## COUNTY OF AMHERST

#### Subdivision Review Staff Report – June 21, 2018

**RE:** Proposed Major Subdivision  
Tax Map Parcel No. 155-A-195  
Ridge Street, Madison Heights  
Subdivision Plat for an eight lot subdivision in the R-1 Limited Residential District

VDOT's 04/06/2018 Comments

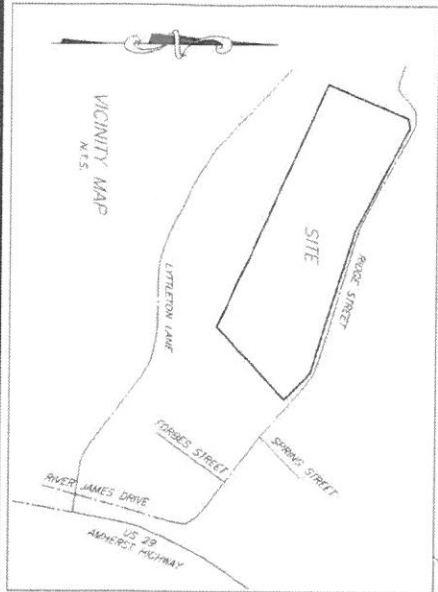
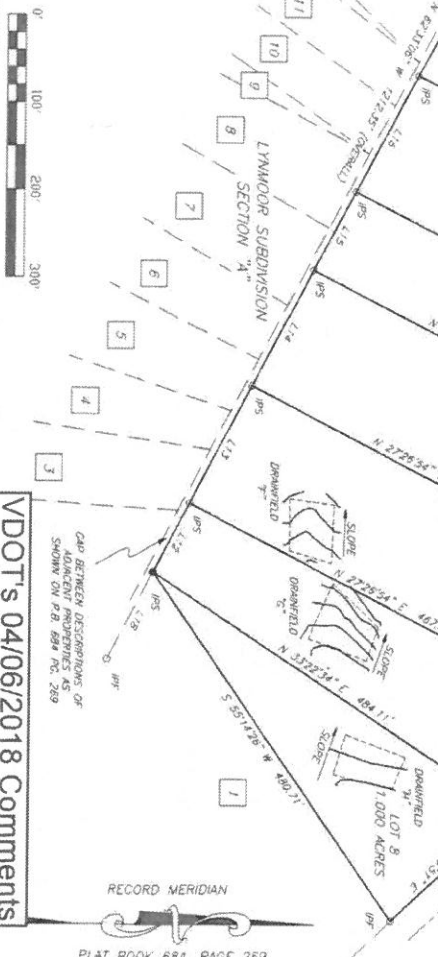
Replace with:  
**ACCEPTABLE TO VDOT**  
**VDOT REPRESENTATIVE:**  
**VDOT'S SIGNATURE IS NOT AN ENDORSEMENT OF THE**  
**ACCURACY OF THE SURVEY**

Due to existing drainage along Ridge  
 Street fronting Lots #1-8 out falling on  
 Lot 1, we request that an out fall ditch  
 be defined through Lot #1 within a 15'  
 drainage easement dedicated to  
 Amherst County along a path  
 determined by the surveyor.
